Project	IEEE 802.16 Broadband Wireless Access Working Group < http://ieee802.org/16 >	
Title	Enhancement of the Multicast & Broadcast Rekeying Algorithm	
Data Submitted	2004-11-04	
Source(s)	Seokheon Cho SungCheol Chang Chulsik Yoon, ETRI	Voice: +82-42-860-5524 Fax: +82-42-861-1966 chosh@etri.re.kr
	161, Gajeong-dong, Yuseong-Gu, Daejeon, 305-350, Korea	
Re:	IEEE 802.16e Security Ad Hoc	
Abstract	The supplementary contents for the efficient rekeying method for the multicast service and the broadcast service	
Purpose	The document is submitted for review by 802.16 Working Group members	
Notice	This document has been prepared to assist IEEE 802.16. It is offered as a basis for discussion and is not binding on the contributing individual(s) or organization(s). The material in this document is subject to change in form and content after further study. The contributor(s) reserve(s) the right to add, amend or withdraw material contained herein.

Enhancement of the Multicast & Broadcast Rekeying Algorithm

Proposed changes

Figure 137b- MBRA management

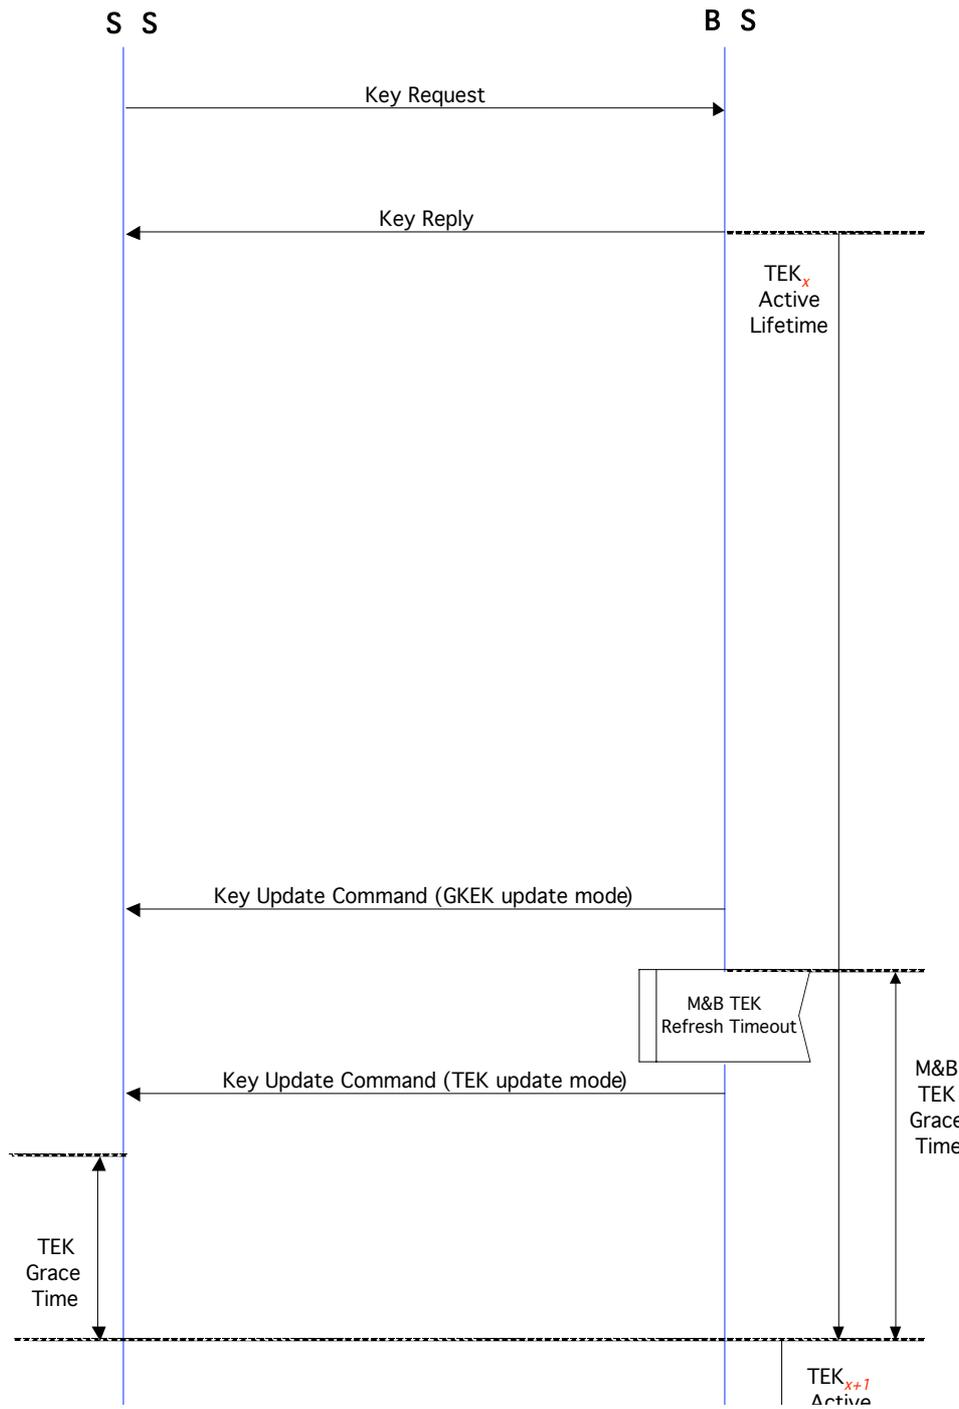
[Modify as the following in section 7.9.1]

The MBRA overall flow is shown in the Figure 137b.

An MSS may get the traffic keying material before an MSS is served with the specific multicast service or the broadcast service. The initial GTEK request exchange procedure is executed by using the Key Request and Key Reply messages that are carried on the Primary Management connection. Once an MSS shares the traffic keying material with a BS, an MSS doesn't need to request the new traffic keying material. A BS updates and distributes the traffic keying material periodically by sending two Key Update Command messages.

A BS distributes updated traffic keying material by sending two Key Update Command messages before old distributed GTEK is expired. The usage type of these messages is distinguished according to the Key Push Modes included in the Key Update Command message.

A BS transmits the Key Update Command message for the GKEK update mode to each MSS served with the specific multicast service or the broadcast service before the M&B TEK Grace Time starts. The purpose of the Key Update Command message for the GKEK update mode is to distribute the GKEK (Group Key Encryption Key). The Key Update Command message for the GKEK update mode is carried on the Primary Management connection. A BS intermittently transmits the Key Update Command message for the GKEK update mode to each MSS in order to reduce the BS's load in refreshing traffic key material. The GKEK is needed to encrypt the new GTEK. The GKEK can be randomly generated in a BS or an ASA server.

A BS transmits the Key Update Command message for the GTEK update mode carrying on the Broadcast connection after the M&B TEK Grace Time starts. The aim of the Key Update Command message for the GTEK update mode is to distribute new GTEK and the other traffic keying material to all SSs served with the specific multicast service or the broadcast service. This GTEK is encrypted with already transmitted GKEK.

If an MSS receives the valid two Key Update Command messages and shares new valid GKEK and GTEK with a BS, then that MSS doesn't need to request a new set of traffic keying material.

If an MSS doesn't receive at least one of two Key Update Command messages, then that MSS sends the Key Request message to get a new traffic keying material. A BS responds to the Key Request message with the Key Reply message. In other words, if an MSS doesn't get valid new GKEK or GTEK, then the GTEK request exchange procedure initiated by a MSS is executed.
